6572A-06

6572A Non System DC Power Supply

Slow or No Down Programming capability

Instructions for Down Programmer Upgrade Kit Agilent p/n 5010-1756

Pic_1

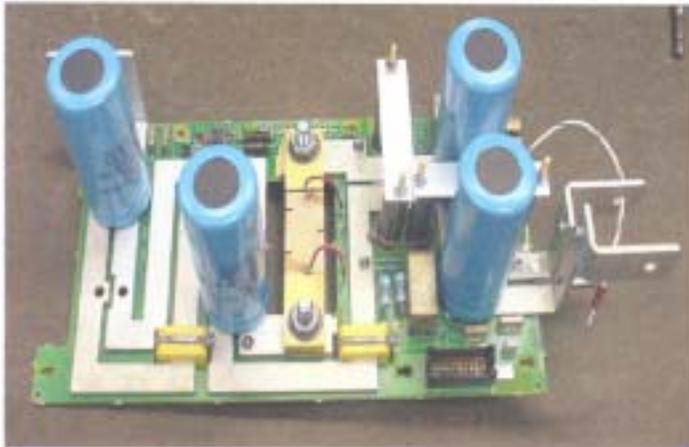
Change: Resistors Reference designator R911 and R912

From: Old part number 0699-1060 (0.05ohm +/-1%, 3W)

To: New part number 0699-1075 (0.1ohm +/-3%, 3W.) (See Pic_1)

Pic_3

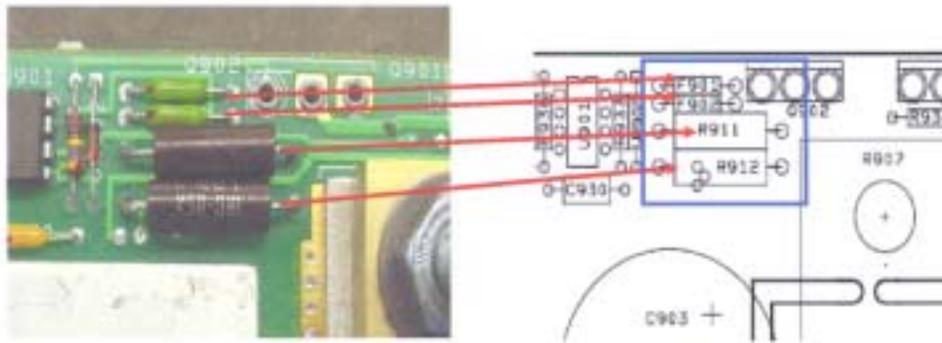
1. Location of the main rework that needs to be done. As per Pic_3 below in blue blocks.

2. Remove Fuses F901, F902 (2110-0713) and old Resistors R911, R912 (0699-1060) as shown in above Pic_3.
*Note: (MUST DO) both fuses due to parts are in parallel.
Both fuses need to be replaced with new parts to ensure the reliability of the product.*
3. Replace both fuses F901, F902 (2110-0713), 10A 125V NTD
Note: Fuses are heat sensitive. Do not subject fuse to soldering iron heat for long period of time.
4. Install New resistors R911, R912 (0699-1075) FXD 0.1 OHM +-3%, 3W

Pic_4

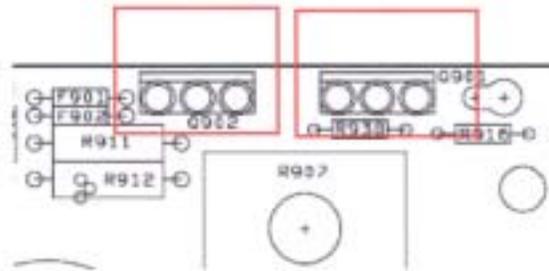
5. Remove Transistors Q901 & Q902, see Pic_4 for location.

Note: Some PCAs will have transistors installed in sockets. If so, remove sockets and replace with new sockets. Be careful not to get solder inside socket.

Note: Do not install Q901 and Q902 transistors until after PCA is put back into chassis.
